Wisconsin Department of Transportation

Proposal #25: 1560-00-70, WISC 2022043
Spoooner - Hayward
Greenwood Ave To Poplar Street
USH 63
Washburn County

This is Addendum No. 02, which provides for the following:

Addendum No. 02
ID 1560-00-70
Revised Sheet 12
November 4, 2021

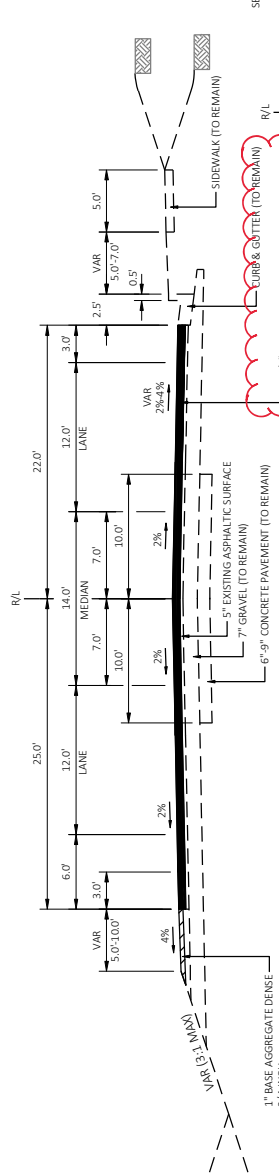
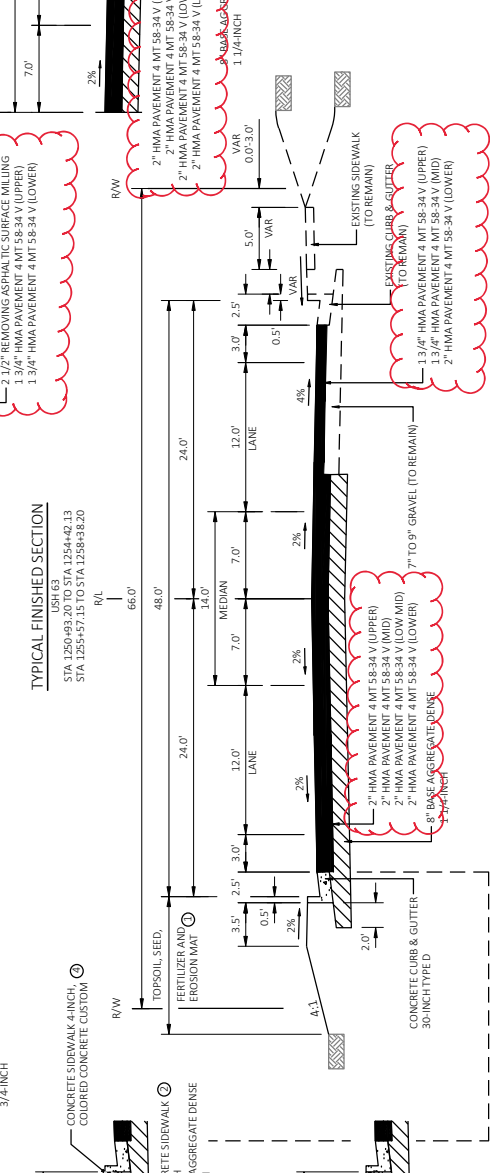
Revised Plan Sheets	
Plan Sheet	Plan Sheet Title (brief description of changes to sheet)
12-16	Revised the HMA mix type and lift thicknesses as required.
237	Replaces the 5 HT 58-28 H & 4 HT 58-34 H with one mix. Also updates the Tack Coat quantity.
